2018SSH042 - 2, 2A, 4 Locksley Street, Cronulla &
31, 37, 39 Sturt Road, Cronulla

MA18/0308

ASSESSMENT REPORT APPENDICES

RE: RESPONSE TO REQUEST FOR INFORMATION IN RELATION TO S4.55(2) MODIFICATION APPLICATION TO DA16/0994 (MA18/0308) FOR DEVELOPMENT AT , 2A & 4 LOCKSLEY STREET AND 31-39 STURT ROAD, CRONULLA

Figure 3: Extent of proposed plant room above ground level (Source: MDP Architects)

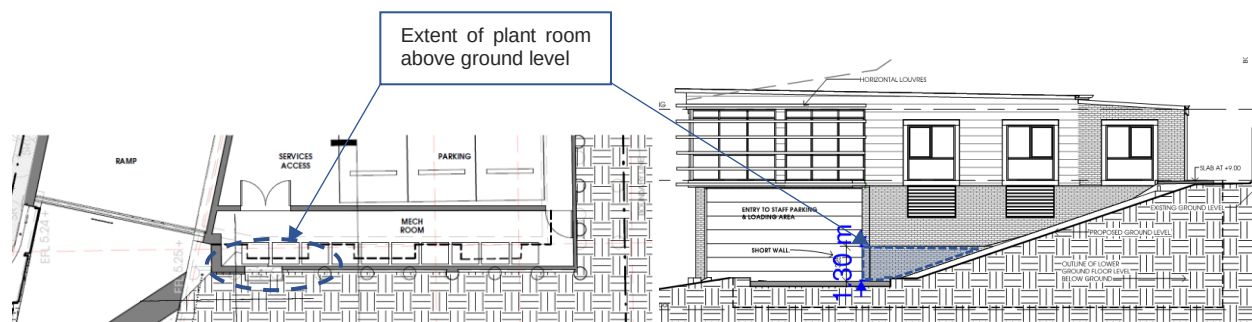
Council were concerned about the presentation of the proposed 'plant room' that is located on the western side of the Norfolk building on the Ground Floor. The proposed plant room is predominately located below ground level and will not be visible from the public domain at any point. A minor portion of the plant room extends above the proposed ground level by a maximum of 1.27m for a portion of the frontage to Locksley Street, as demonstrated below in **Figure 3**.

The extent the plant room extends above ground level is minor, and does not impact on the streetscape. The materials of the plant room are similar to that of the wall of the building behind. Notwithstanding, the proposed landscaping will screen this element from the public domain once matured, as demonstrated in **Figure 4**.

Figure 1: Loading Dock Location

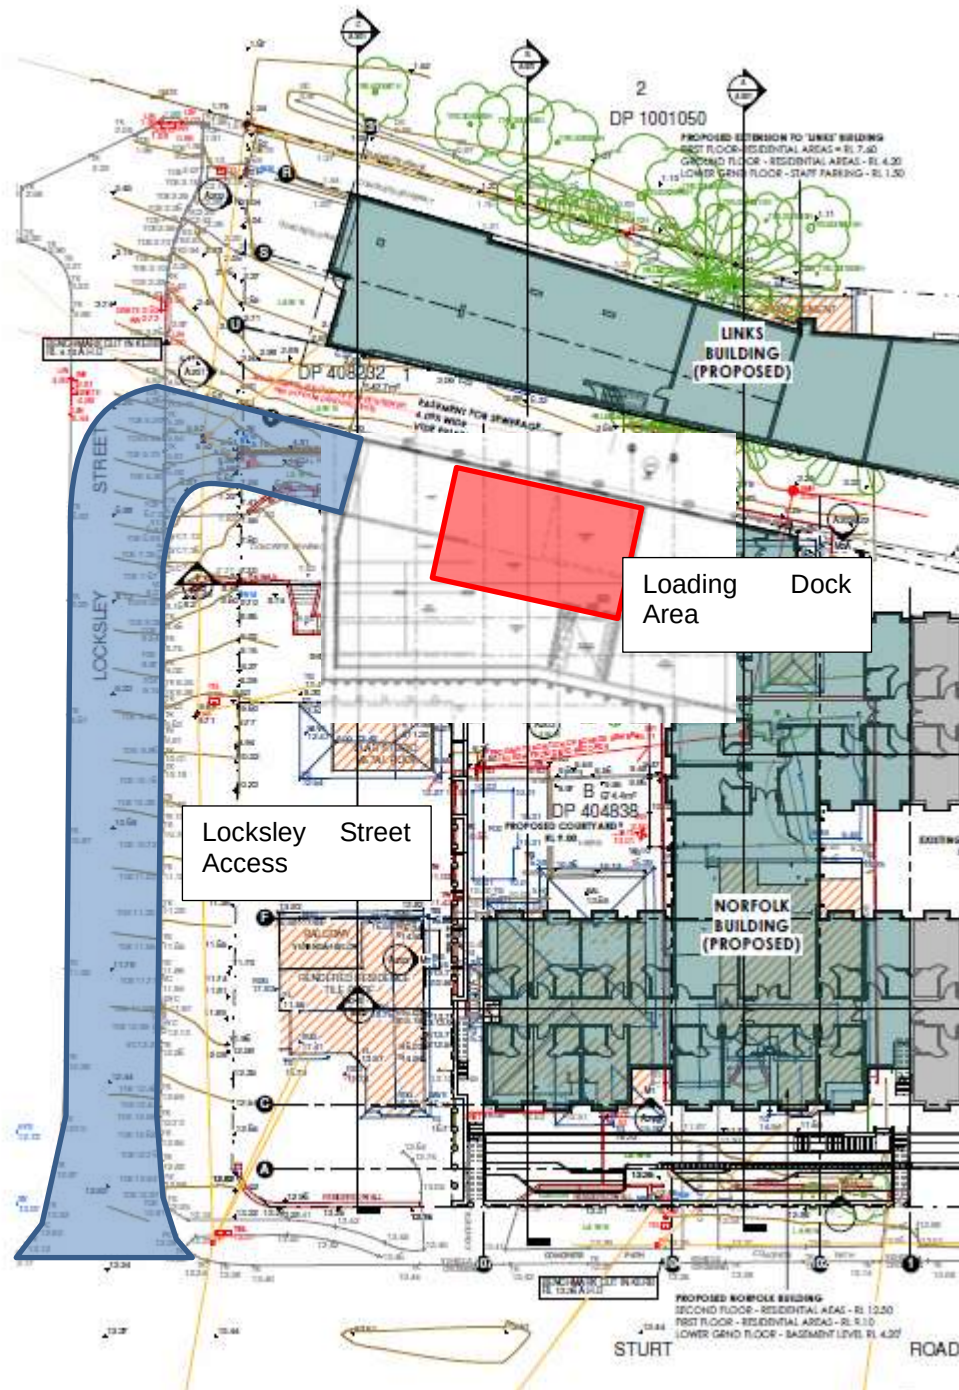
Concern was raised regarding the proposed hours for bread deliveries, which may be as early as 4:30am. As noted in the Delivery Management Plan submitted with the application, bread deliveries will occur a maximum of three (3) times per week. The reason bread is delivered at these times is so that the residents of the facility can be provided fresh bread. The provider of the bread (Goodman Fielder) only deliver their bread at this time of the day, after it is baked. This is a common delivery time for bread providers across the industry. The Acoustic Statement provided by EMF Griffiths provides management solutions to ensure that the surrounding residents within Locksley Street will not be adversely impacted by noise as a result of these deliveries.

The loading dock is approximately 30m from the nearest residence.
